RE: **Winrock Road Town Center**
2100 Louisiana Blvd NE
Drainage Master Plan- Drainage Implementation Plan
Engineer's Stamp Date: 5/16/19
Hydrology File: J19D058

Based on submittal received on 5/17/19, the Drainage Implementation Plan cannot be approved for Site Plan for Building Permit until the following are corrected:

RE: Winrock Town Center Drainage Implementation Plan
Hydrology File: J19D058

WINROCK TOWN CENTER DRAINAGE IMPLEMENTATION PLAN

City Project No.	4553.90	Zone Map No.	J-19-Z	Sheet	Of
				EXHIBIT 1

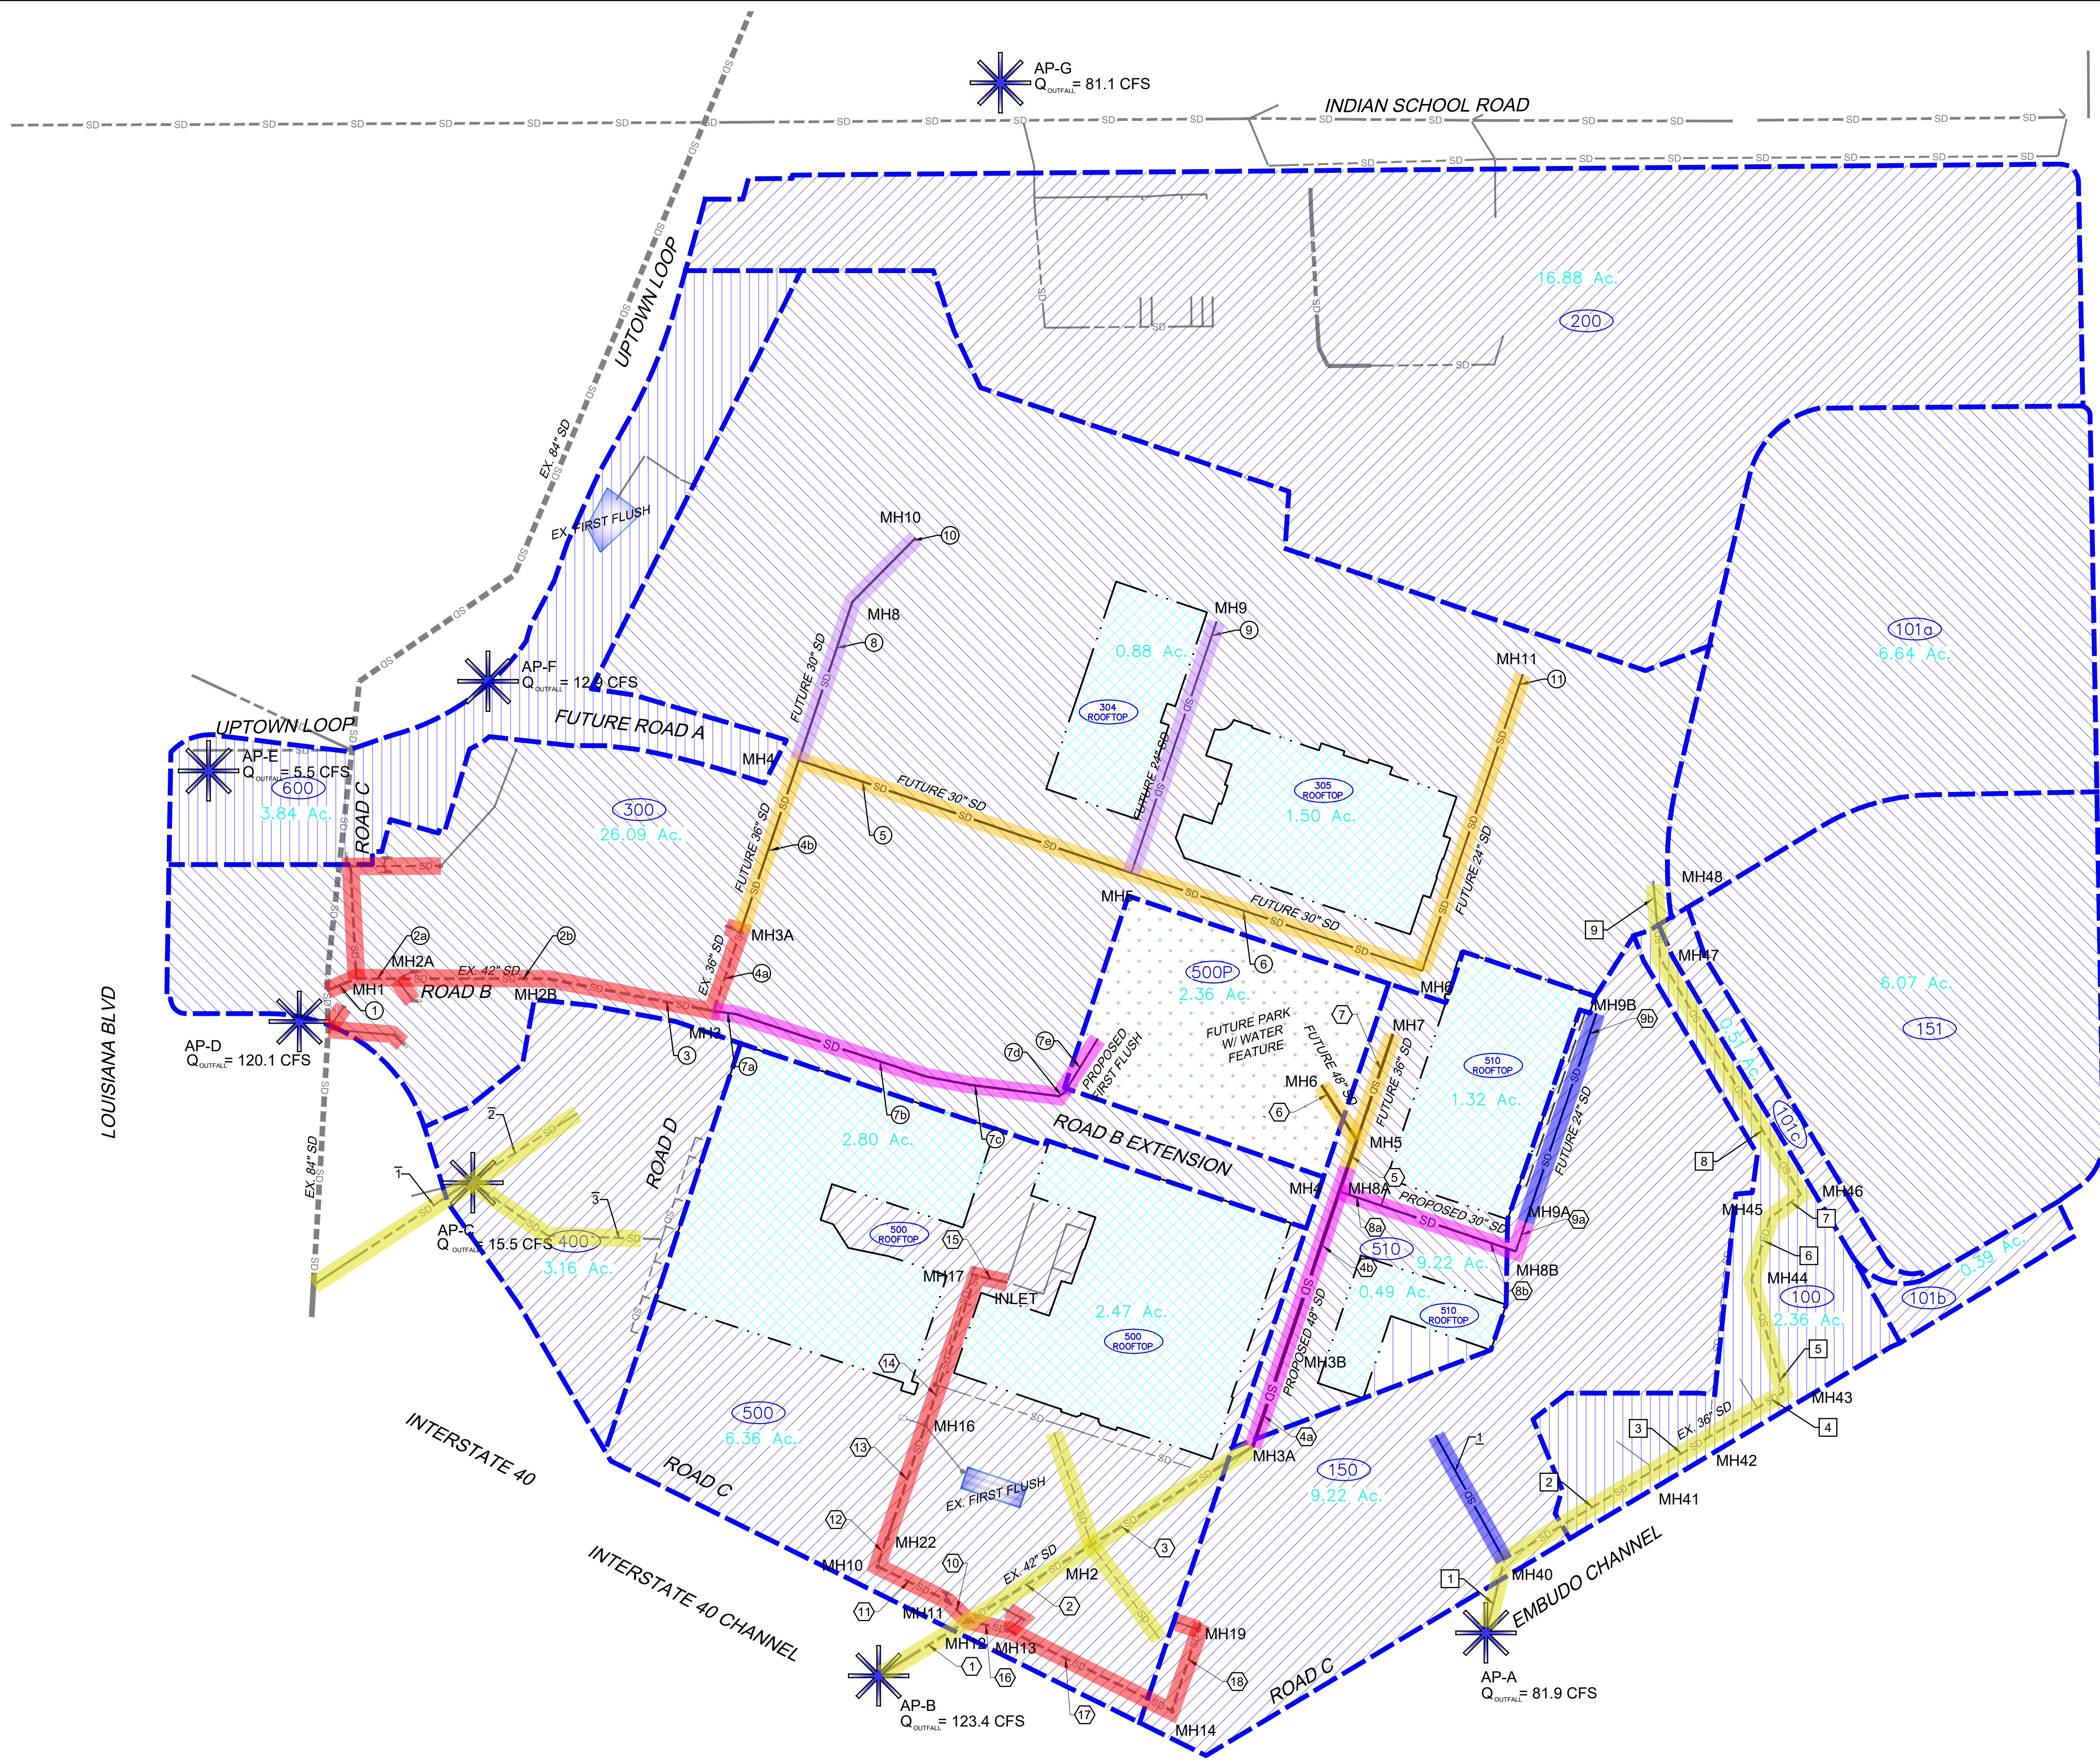
1. Exhibits 1-8 minor remarks:
 - a. The existing (Pre-DMP) pipes should all be RCP, not HPPP; this will affect the friction slope.
 - b. On Exhibit 2, pipe 2 appears to be mislabeled in plain view.

- iii. pipe 16 Q is 14.3cfs, but is shown as 22cfs on the exhibit 1 table.
 - d. On Exhibit 4,
 - i. pipe 6 is called out as 48" in profile and on the exhibit 1 table, but is 36" in the table;

- ii. pipe 6 Q is shown as 24cfs on the table, but is shown as 51cfs on the exhibit 1 table.
 - e. On Exhibit 5, pipe 7a-7e are called out as 30" in profile, but are 24" in the table and 42-30" on the exhibit 1 table

- f. On Exhibit 6, pipe 6 is called out as 30" in profile and 30" on the exhibit 1 table, but is 24" in the table.
 - g. On Exhibit 7, pipe 8 is called out as 30" in profile, but is 36" in the table and 36" on the exhibit 1 table

- h. On Exhibit 8, the table and profile and table on Exhibit 1 don't match:
 - i. pipe sizes are inconsistent between the table and profile and the exhibit 1 table;

Exhibit 1 will be included in the DRB Master Site Plan. The DRB Master Site Plan has been coordinated with the Architect's plan.

STORM DRAIN AP-B 100

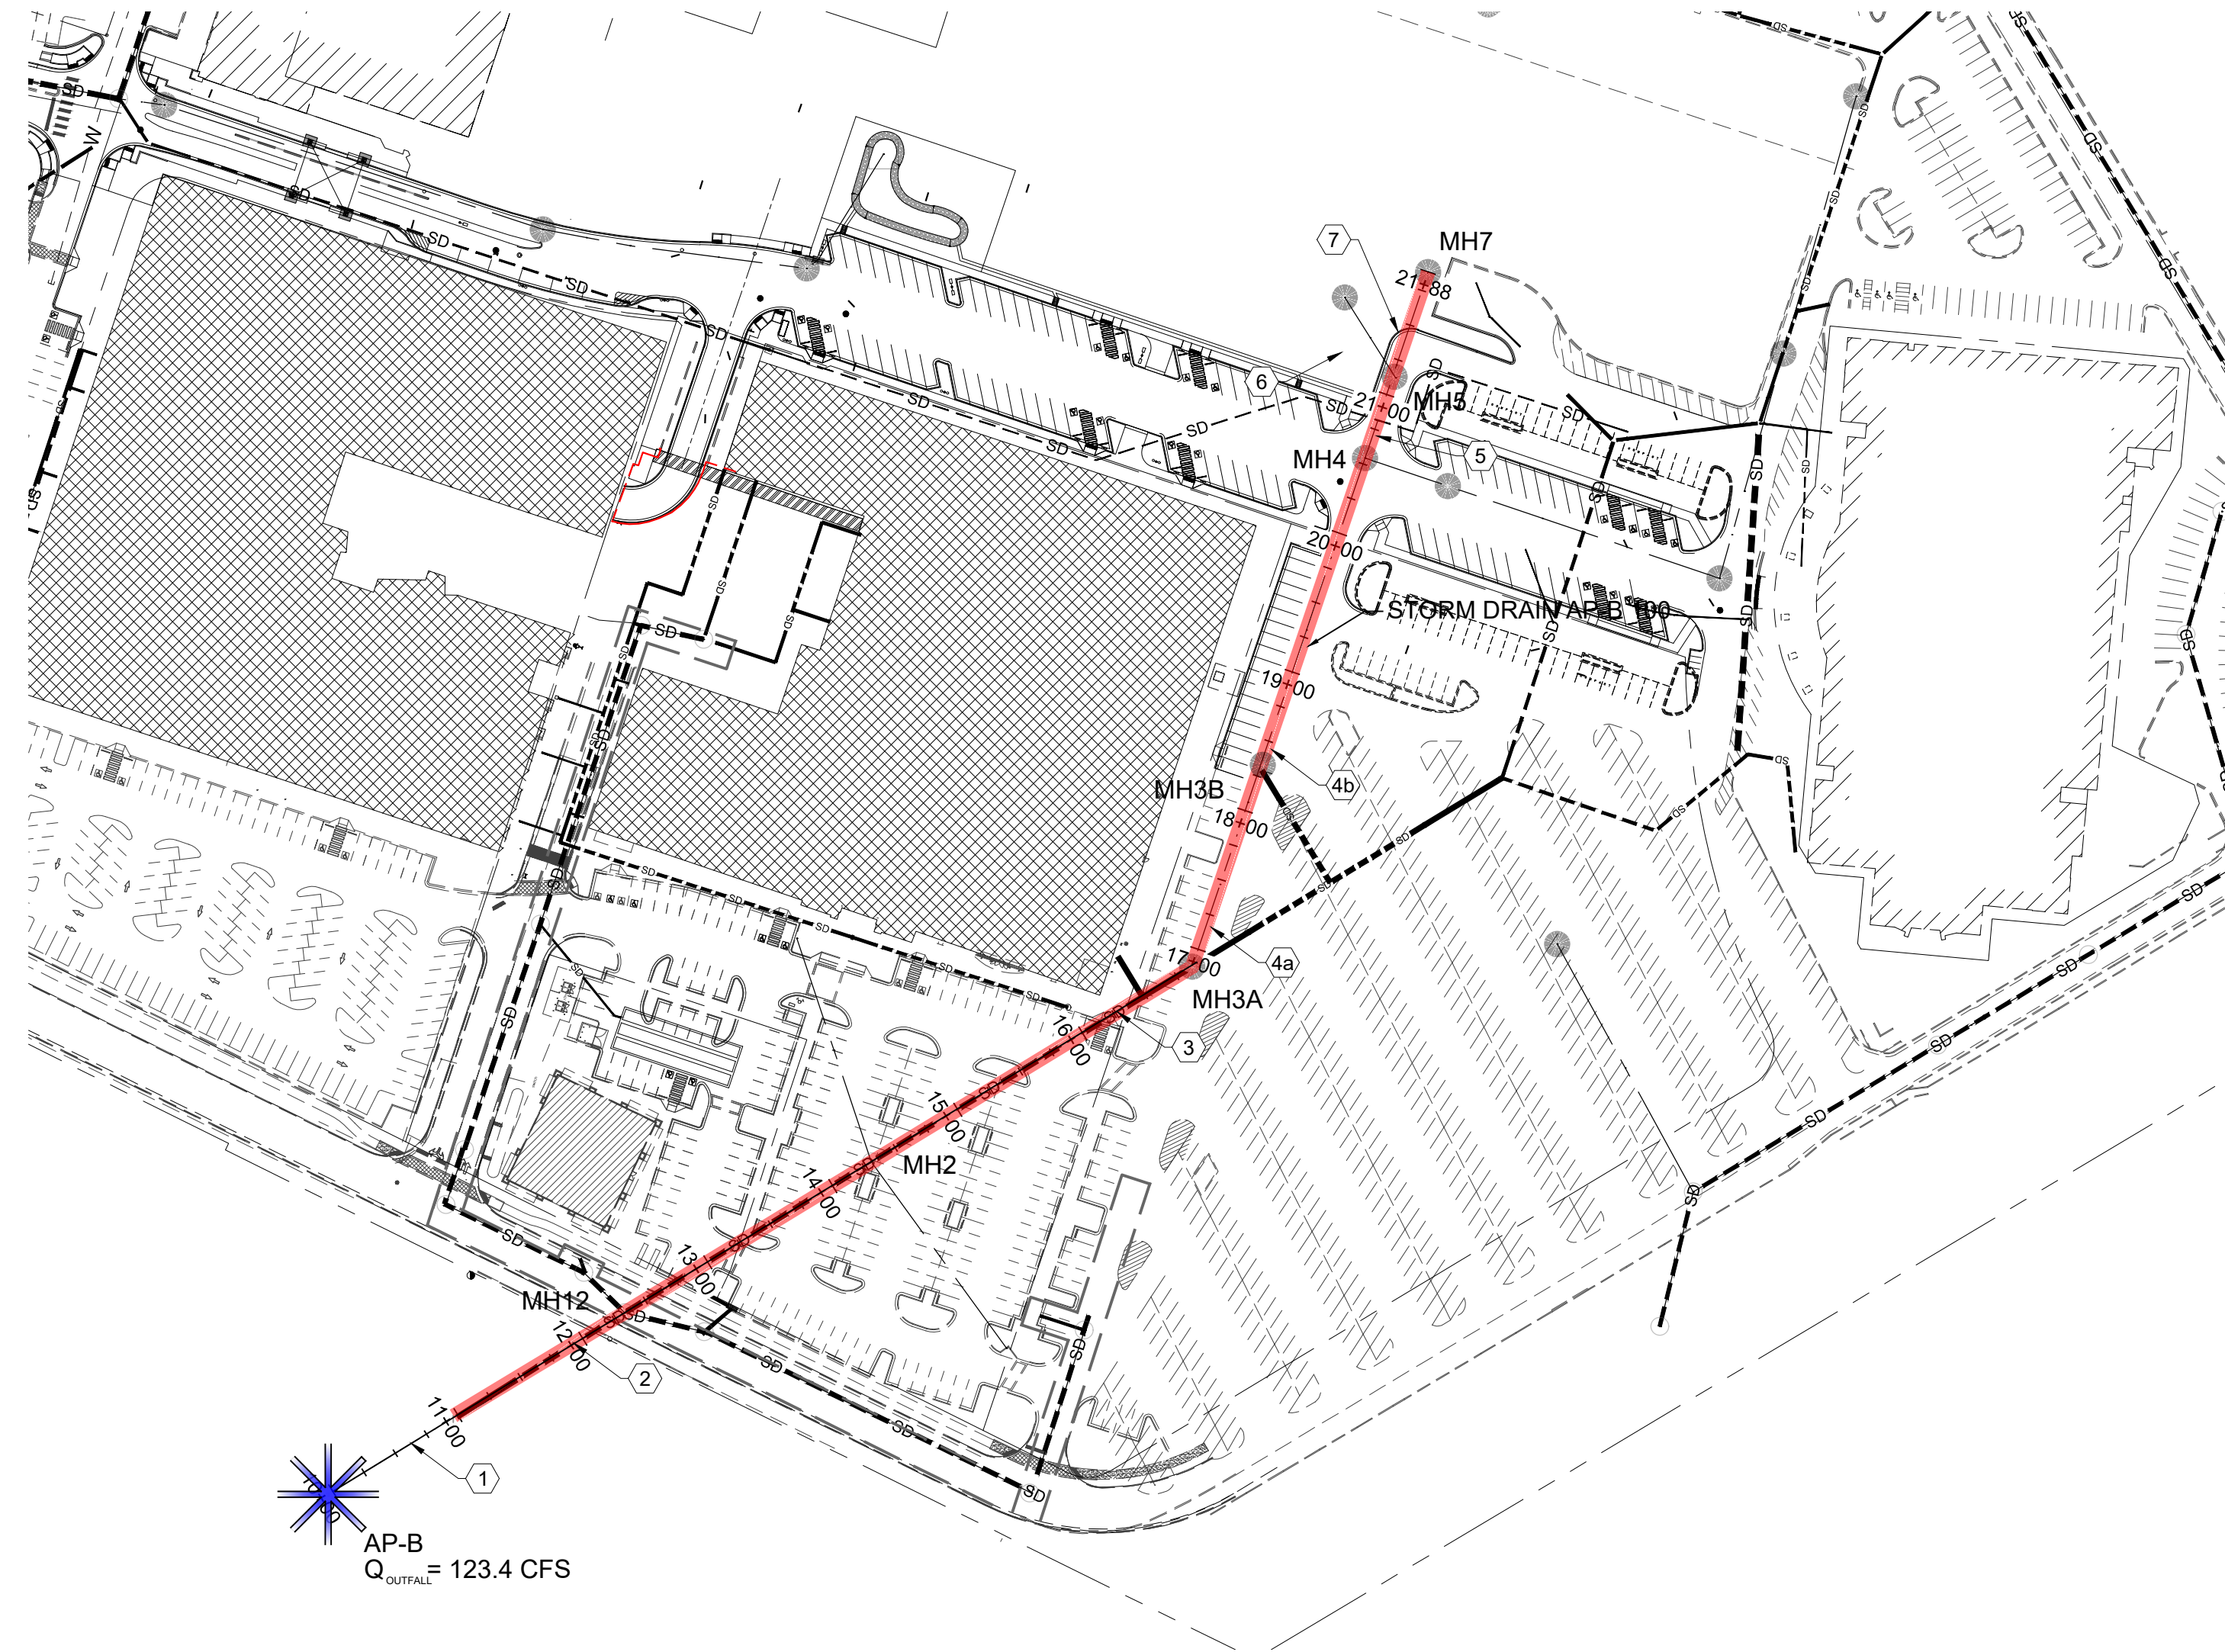
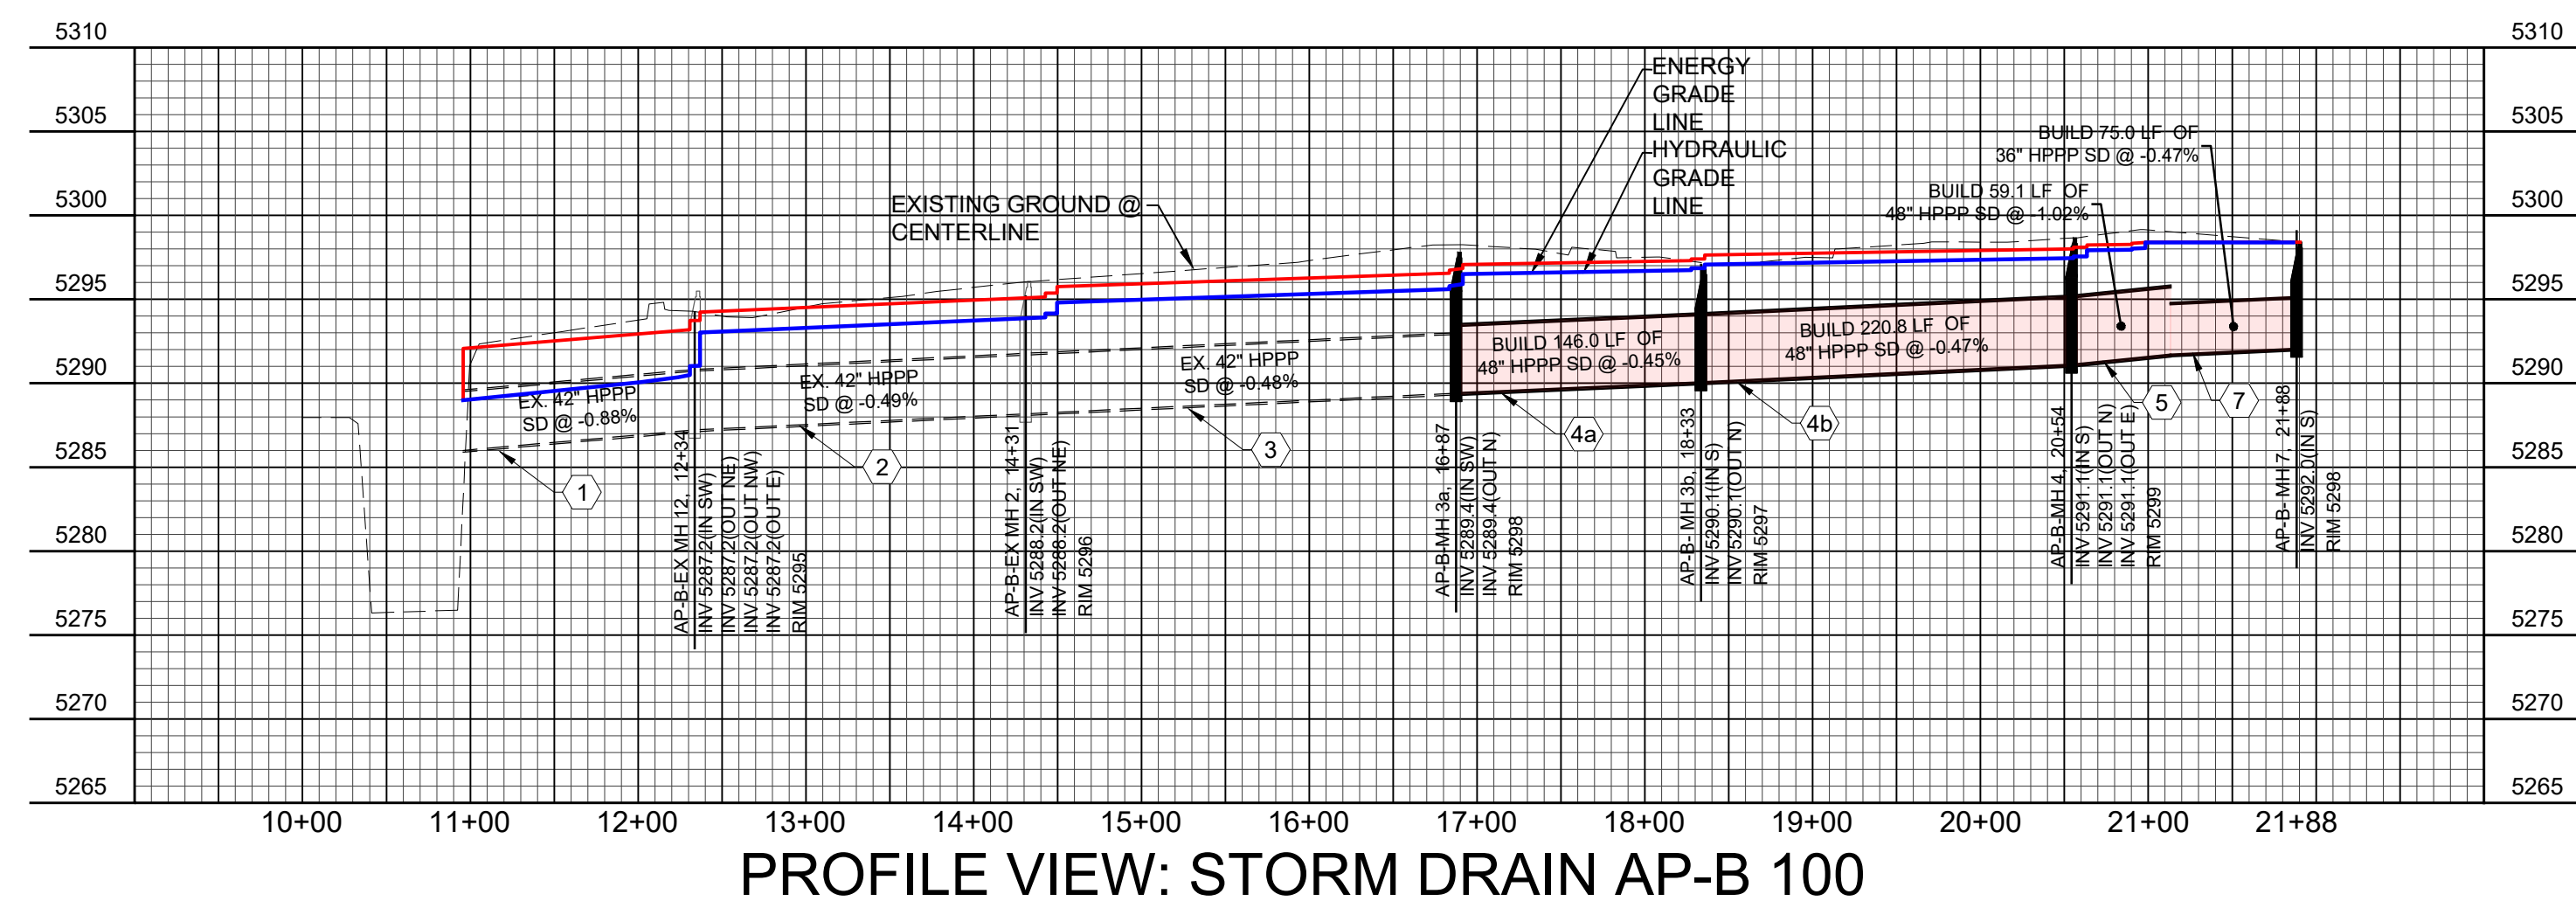
- a. *Please label the manholes in plan view and label the pipes in profile view.*
- b. *On Exhibit 2, Pipe 2 appears to be mislabeled in plan view.*
- c. *Exhibit 4, the profile for AP-B 400 is cropped.*
- d. *Storm drain profile/model for AP-A is missing.*

The exhibits have been corrected and updated.
